ADDENDUM NO. 2

RE: **ATHLETICS DEPARTMENT
University of Wisconsin – Whitewater
Whitewater, Wisconsin**

UWSA Project No.: **N-24-001**

UW-WHITWATER - MILLER
 STADIUM PRESSBOX
 University of Wisconsin-Whitewater
 Whitewater, WI
 Sheet Title:
 FLOOR PLANS - PRESSBOX

5 LEVEL 02 - REFLECTED CEILING PLAN
 1/4" = 1'-0"

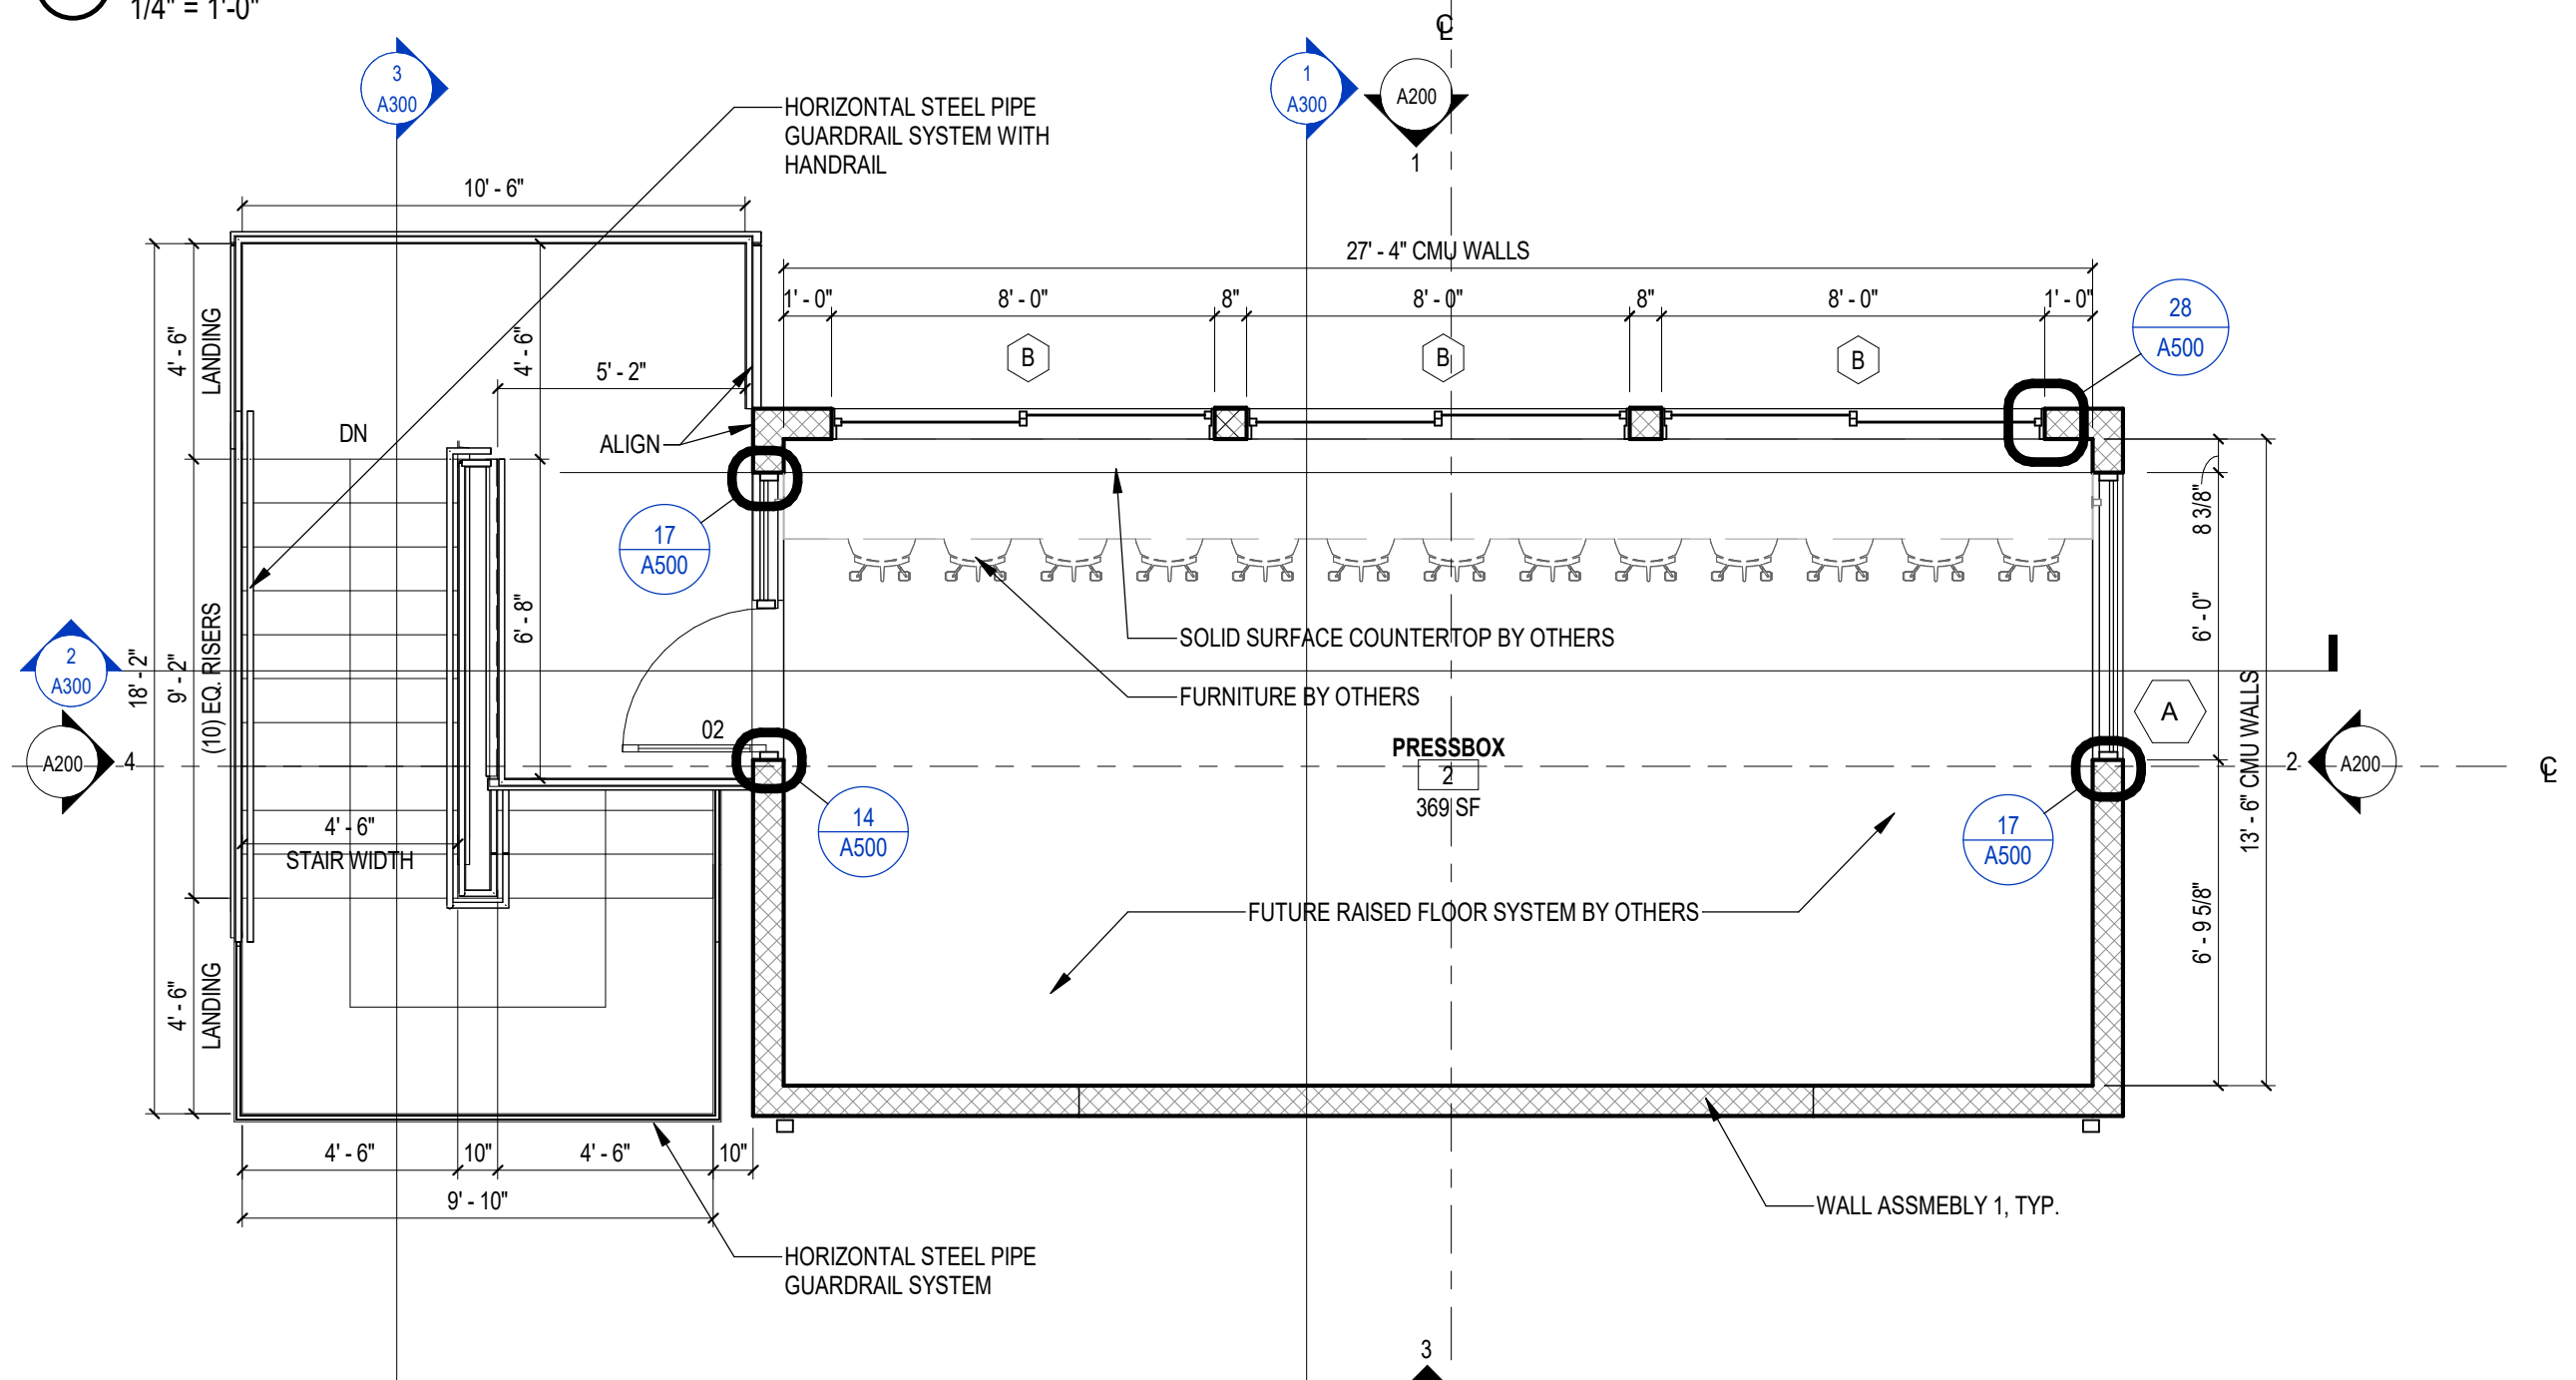
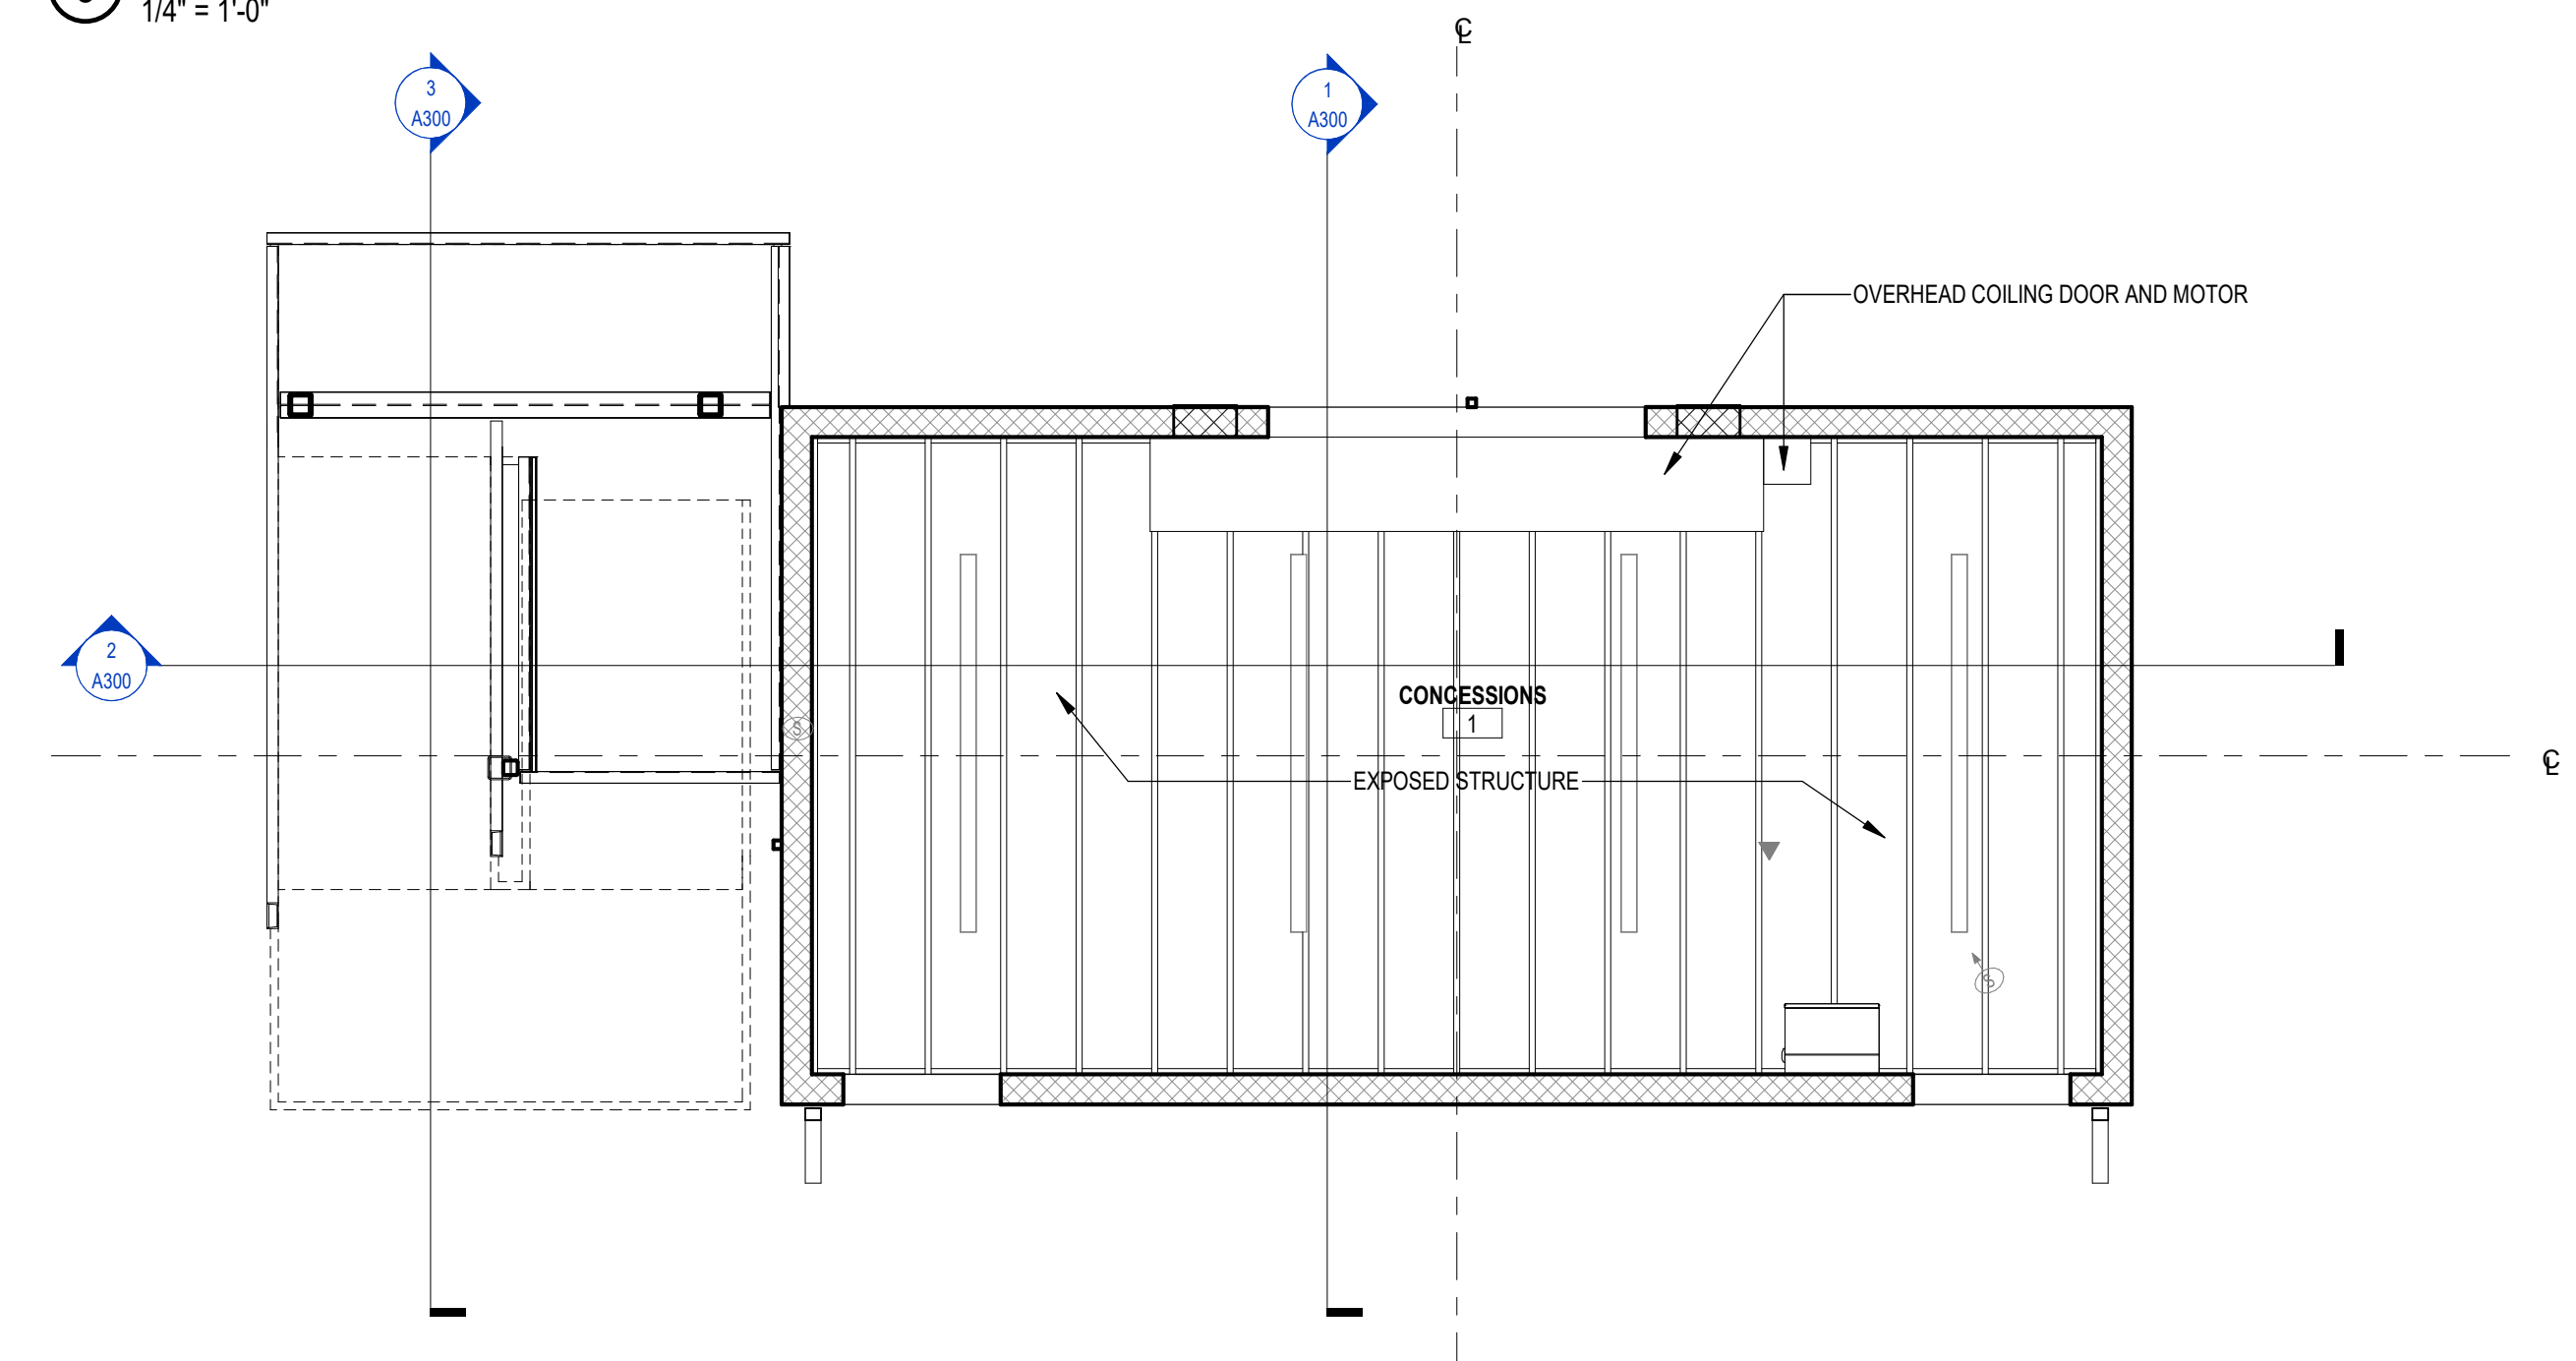
1. Sheet G002 – SPECIFICATIONS
 - a. Replace entire document with attached sheet G002
 - i. Section 08 33 13 – Overhead Counter Doors
 1. Removed lines J. and L.
 2. Revised section “N. Exterior Door Finish”.
 - ii. Section 08 71 00 – Door Hardware
 1. Added section “H. PRODUCTS”
2. Sheet A100 – FLOOR PLANS-PRESSBOX
 - a. Replace entire document with attached sheet A100
 - i. Added notes to door schedule.
3. Sheet A200 – EXTERIOR ELEVATIONS
 - a. Replace entire document with attached sheet A200
 - i. Revised glazing elevation dimensions and added notes.
4. Sheet A500 – DETAILS
 - a. Replace entire document with attached sheet A500
 - i. Revised framing size and insulation note 10/A500.
 - ii. Removed burnished block note 29/A500.
